KiwiRail Regional Freight Hub

S92 RESPONSE LANDSCAPE AND VISUAL EFFECTS ASSESSMENT

Landscape and Visual - S92 Response

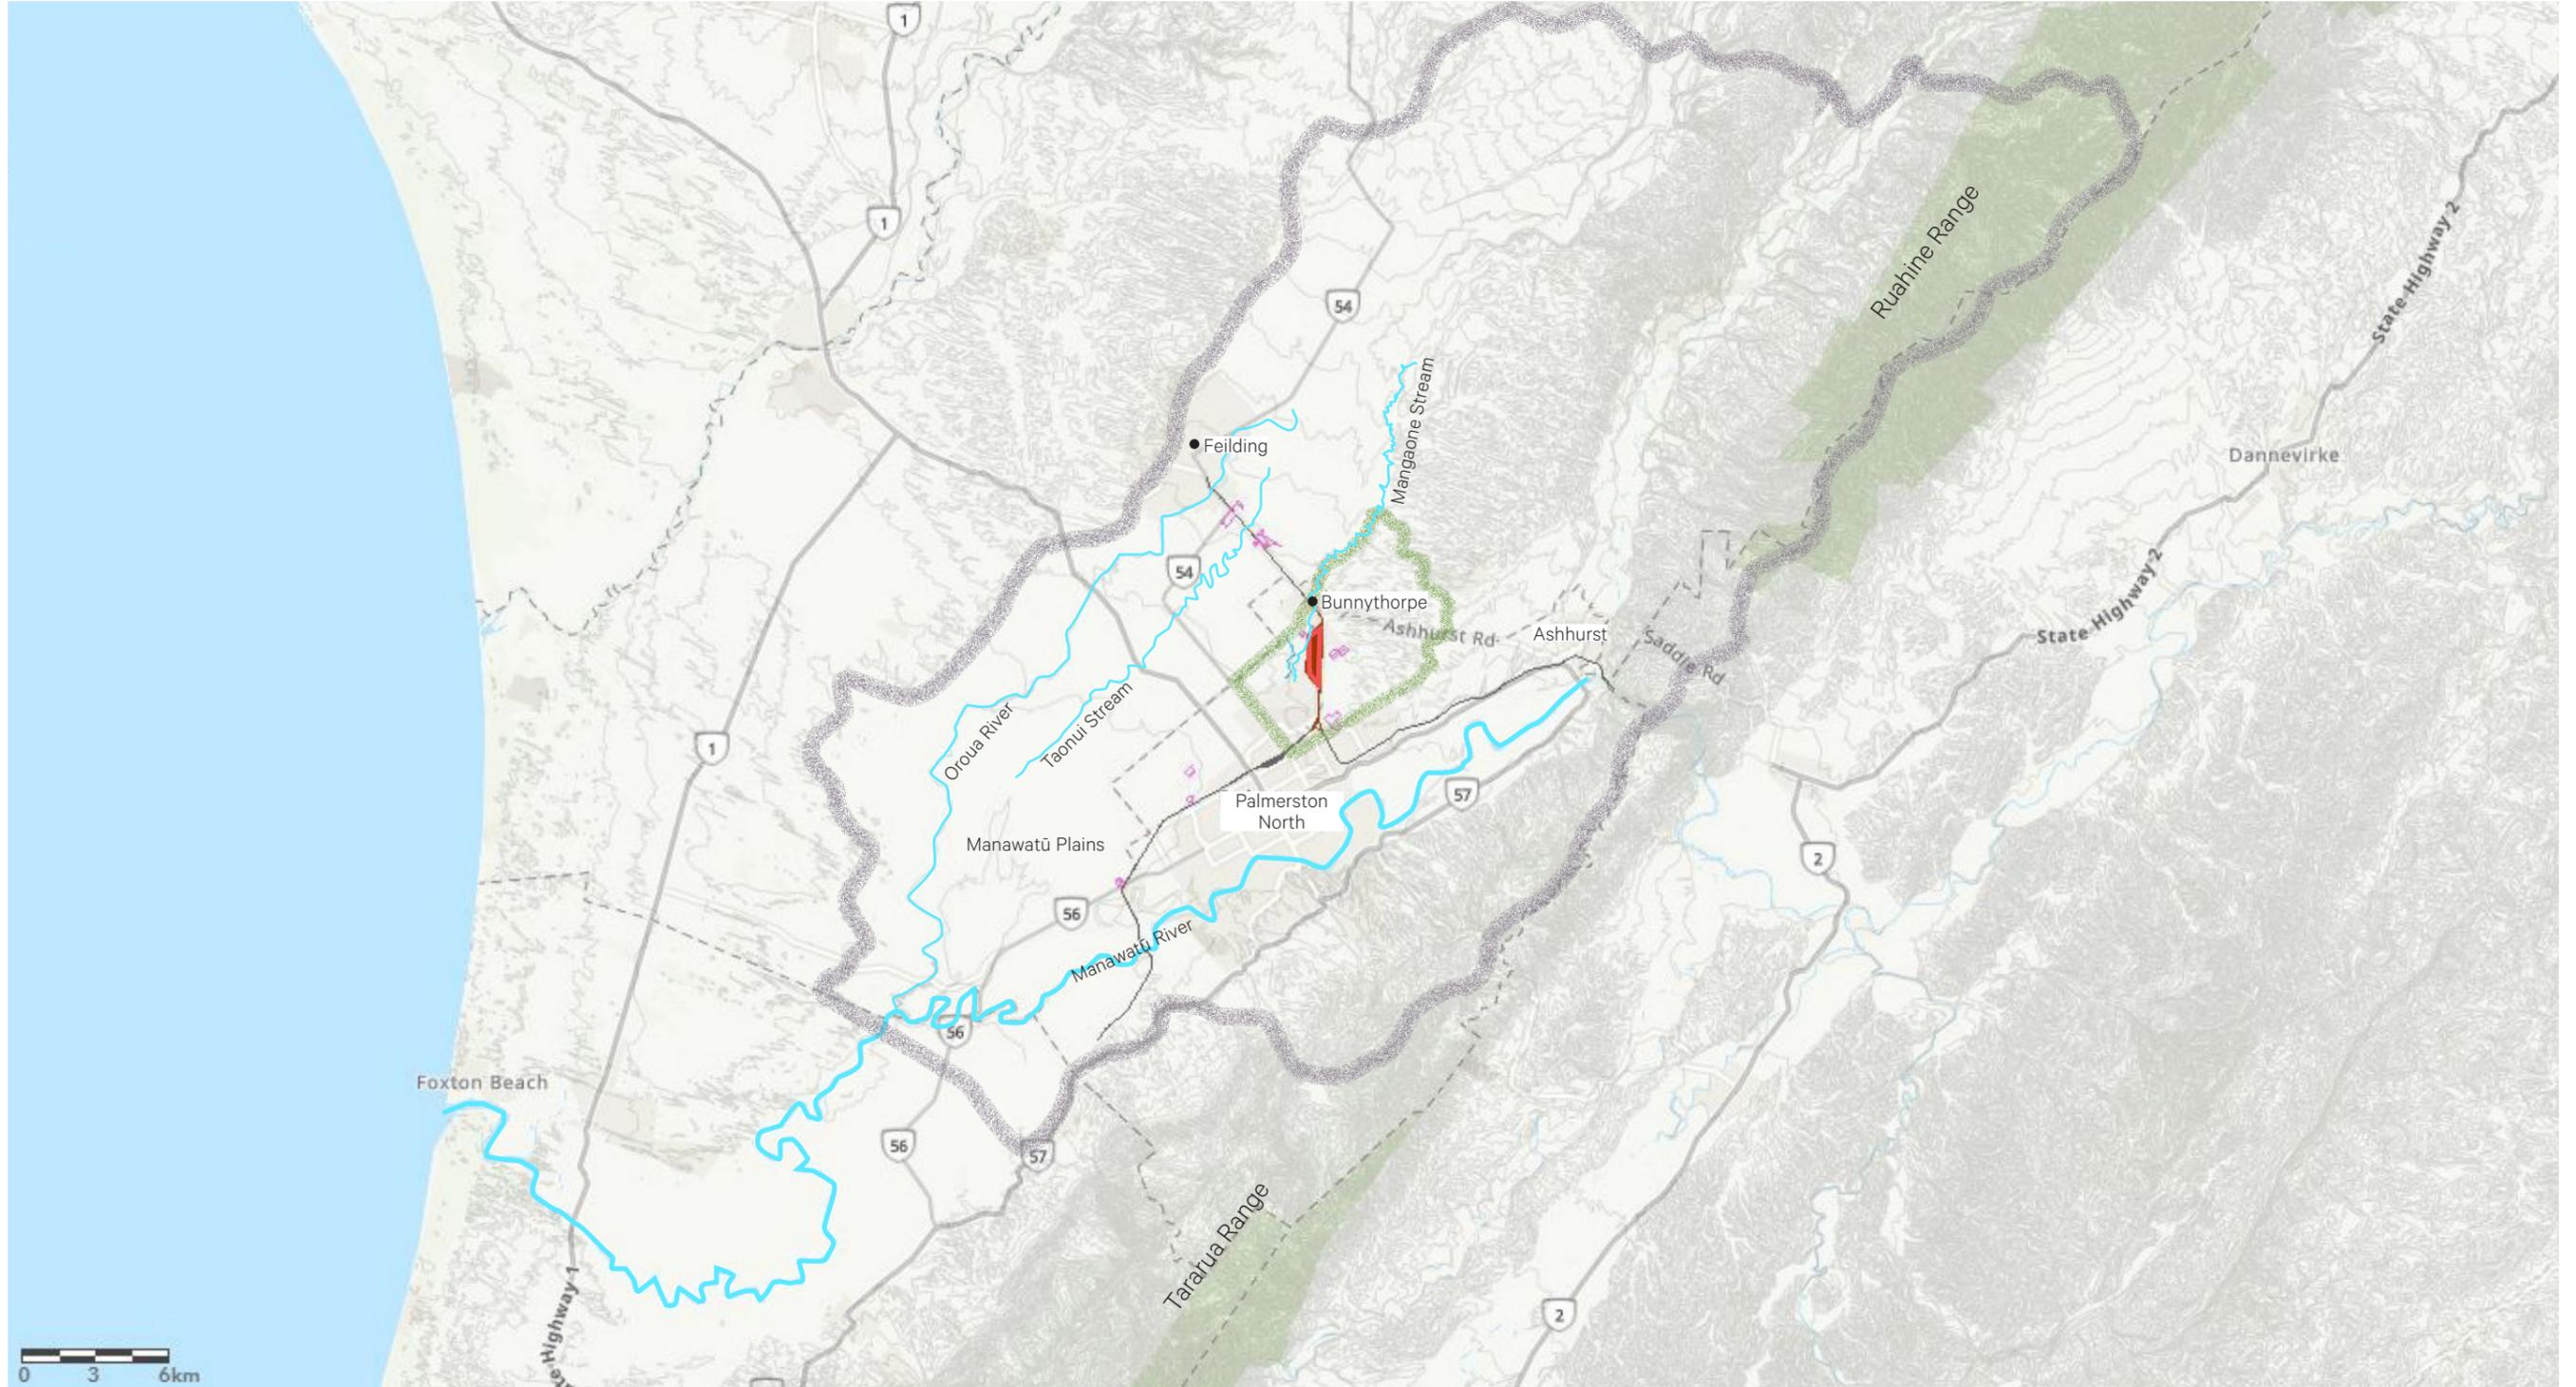
<p>5.3.9 Natural character (LVA report)</p> <p>In the order of 3.8 km of stream length will be modified, primarily through culverting, to enable</p>	<p><i>85) Please provide further information with clear rationale as to how culverting 3.8 km of stream will result in moderate positive natural character effects. In particular, please</i></p>	<p>The existing natural character values of the tributaries within the Designation extent (assumed to be within site scale referred to in the question) are in a heavily farmed existing environment and the natural character of these streams is assessed as low in the LVA. The proposed areas where water will be conveyed or held (e.g wetlands, ponds and open channels) within the Designation will be naturalised and these areas will support habitats and will add better connections. In addition, the open naturalised channel will provide habitat opportunities for fish (increased habitat and hydraulic variability, fish passage will be provided for and hydrological patterns will be at least maintained). Collectively these works, along with extensive areas of planting proposed, will result in the moderate positive natural character effects referred to.</p>

Reason given in PNCC letter	S 92 Request	Response
<p>development of the site. Following development, a constructed stream is proposed to remain as open channel.</p>	<p><i>provide an assessment at both the reach and within site scale, with specific regard to the quantum of open stream length that will remain that could have natural character values.</i></p>	<p>The assessment of 'natural character' has considered the quantum of stream being culverted, the existing natural character values of these areas and the proposed design. This includes the naturalised channel, wetlands, and ponds along with the River Plain and Wetland type planting. These features will be physically connected to, and be perceived as part of, the Mangaone Stream environs. The assessment considers a range of relevant factors and values that form and contribute the natural character. In terms of best practice guidance, this cannot be limited to a consideration of stream loss.</p> <p>In response to the second part of the question.</p> <p><i>The assessment at both the reach and within site scale requested in regard to the quantum of open stream length that will remain that could have natural character values.</i></p> <p>While there will be a loss of existing stream length in the form of culverted streams as set out in the response to Q 80 (in the Ecology Assessment Response Report), the proposal anticipates provision of an integrated river margin environment. This will be established through the naturalised River Plain and Wetland planting which connects the new open channel and stormwater ponds and their discharge section in the Designation extent. These proposed works will not affect the potential for planting and other natural character improvements to the margins of the Mangaone Stream or upstream of the Designation extent. The quantum of open stream length that will exist in the proposed open channel reach is not confirmed, but it is expected the low flow channel will meander through the available wider channel extent, resulting in a longer stream channel than the straight line of this feature's banks. As set out in the stormwater assessment, the Freight Hub Site is part of the wider Mangaone Stream catchment that is in the order of 1,200Ha and while not measured as part of this project, it follows that the total length of the upstream 'reach' will be significant, and of a far greater order than 3.8km</p>
